CD-CPC-2026-00042

Hohl Farm

Development Plan

Plan Conditions, Corrections, & Suggestions Report

ARCHITECTURAL SITE PLAN
1" = 60'-0"

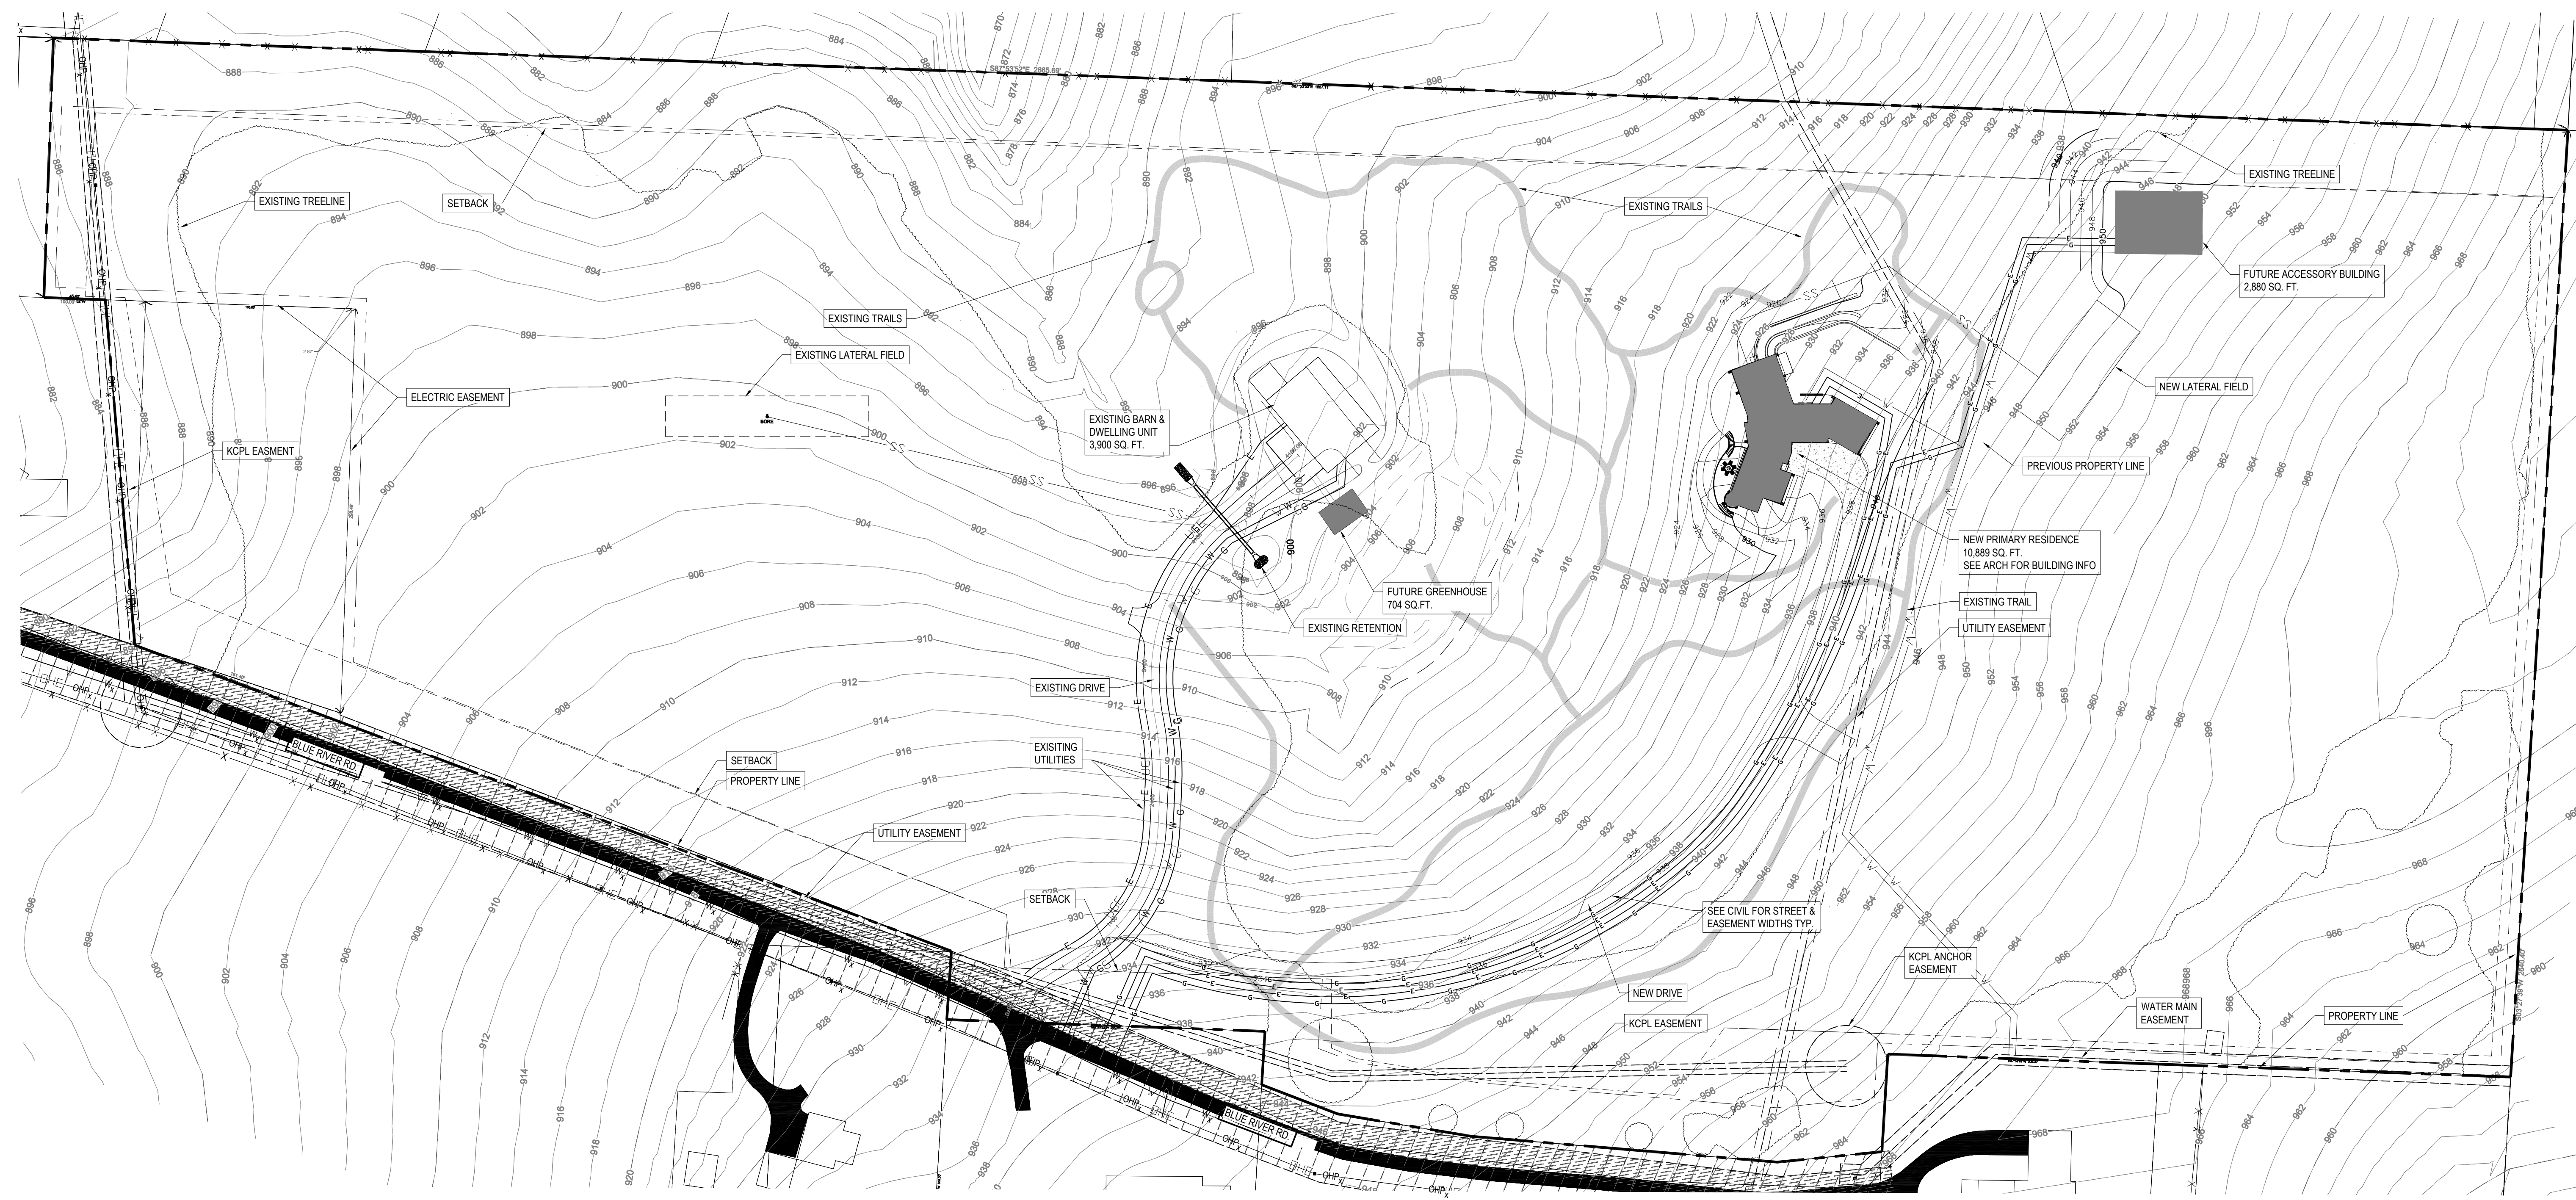
The proposed plan complies with the standards of the Zoning and Development Code except for the accessory structure standards. The proposed greenhouse is in front of the existing principal structure, thus encroaching onto the front yard. Staff included a condition to have the applicant revise the site plan to move the greenhouse back to be either behind or aligned with the front wall of the existing principal building.

3. The applicant shall revise and resubmit the site plan showing the greenhouse to be behind the existing houses prior to ordinance request. (5/14/2026)

SHEET NAME
UTILITY PLAN

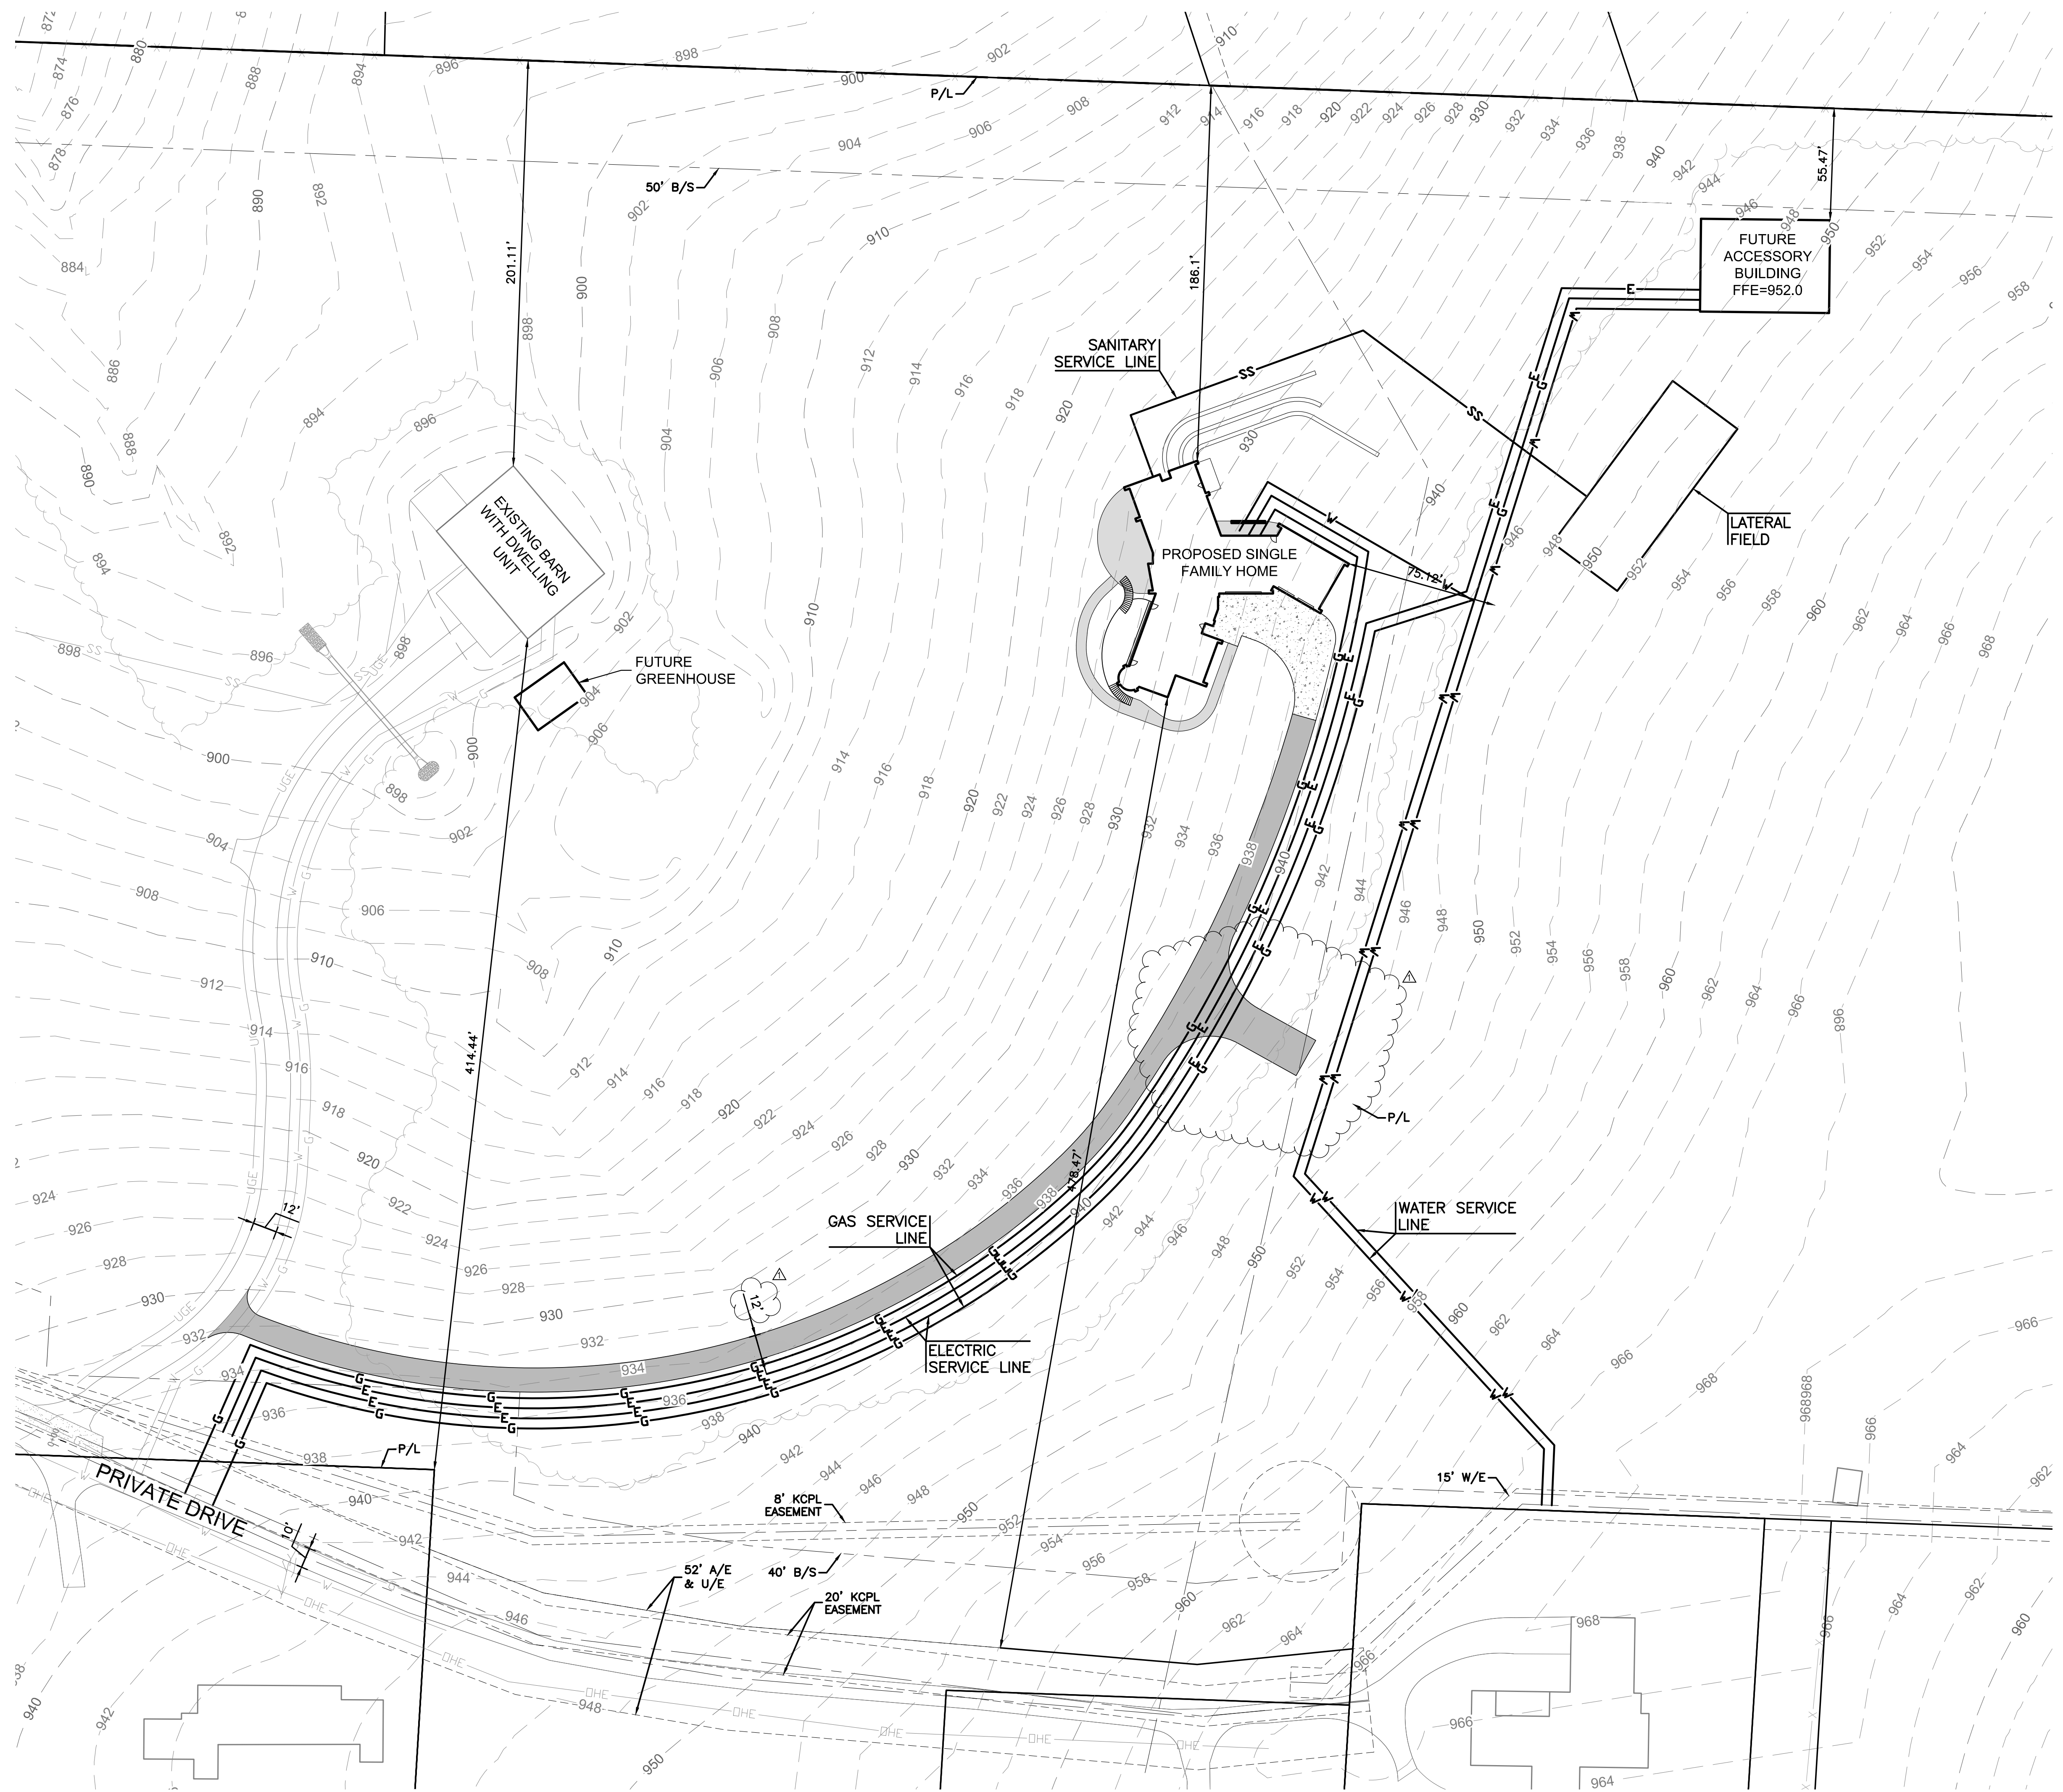
12. The existing water main along Blue River Road is only a 2" diameter main according to our GIS maps. It is likely the 8" DIP water main to the south will need to be extended north to provide adequate flow and pressure for the new fire and domestic demands. If after confirming existing flow and pressure vs. proposed demands a larger main is needed, then the developer shall submit water main extension plans prepared by a Missouri PE for review and permitting through CompassKC. The plans shall be under contract (permit) prior to building permit issuance or final plat recording whichever occurs first. (4/09/2026)
